# Technical Service Information

## **THM 4L60 (700-R4) PREMATURE FORWARD CLUTCH FAILURE**

**Figure 1**

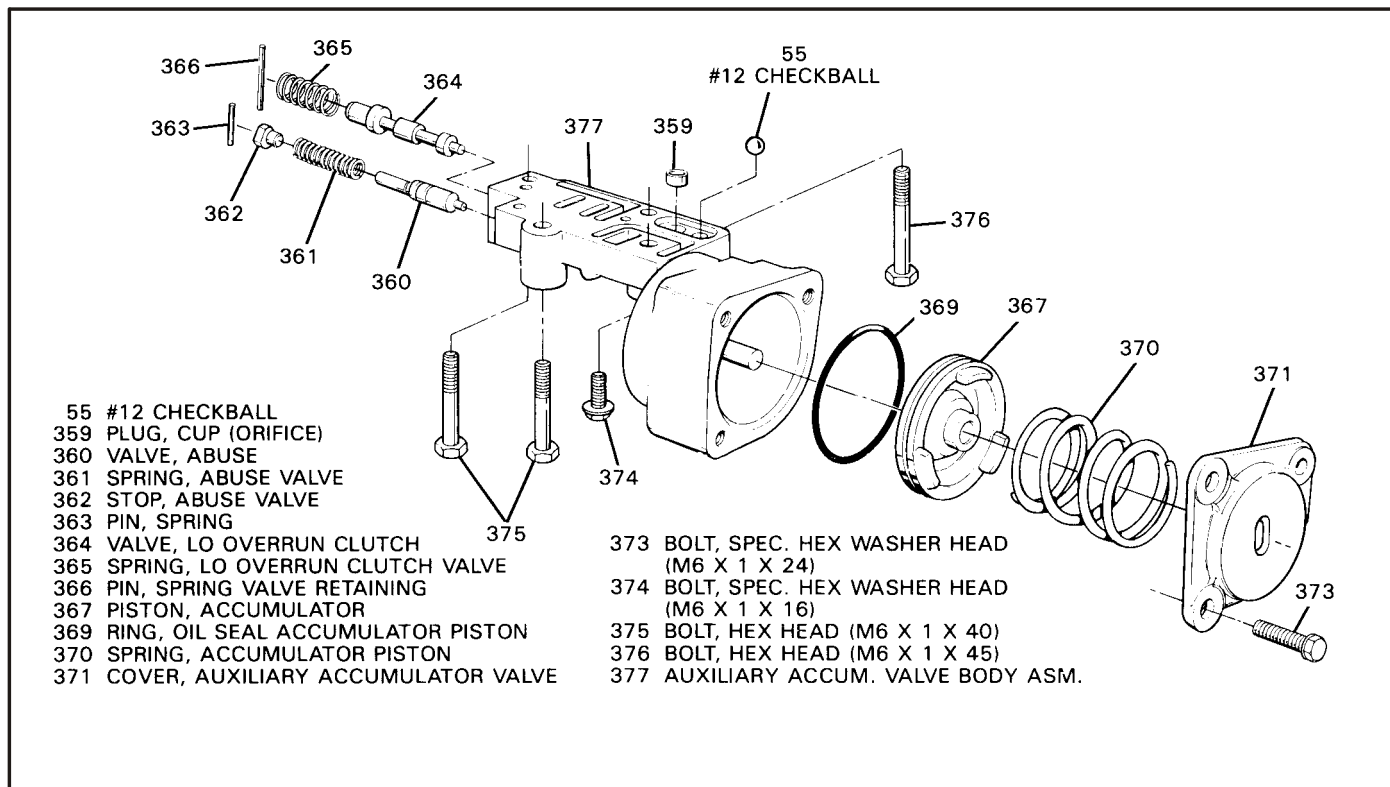
**COMPLAINT:** Premature forward clutch failure on 1987 THM 700-R4 with auxiliary valve body.

**CAUSE:** The cause could be the forward clutch accumulator pin in the auxiliary valve body moving out thru the hole in the center of the 1st design accumulator cover, and creating a loss of forward clutch oil. The original press fit of the pin was not sufficient to retain the pin in the auxiliary valve body casting.

**CORRECTION:** If you have the 1st design cover, braze shut the hole in the center of the cover and drill a 3/16" hole off center. (See Figure 1). The 2nd design cover with the oblong hole in the center is OK to use as is. If the pin has moved out the back side of the auxiliary valve body, a simple "staking" process will prevent it from moving that direction again. The 2nd design auxiliary valve body casting has a step machined in that area to prevent the pin from moving.
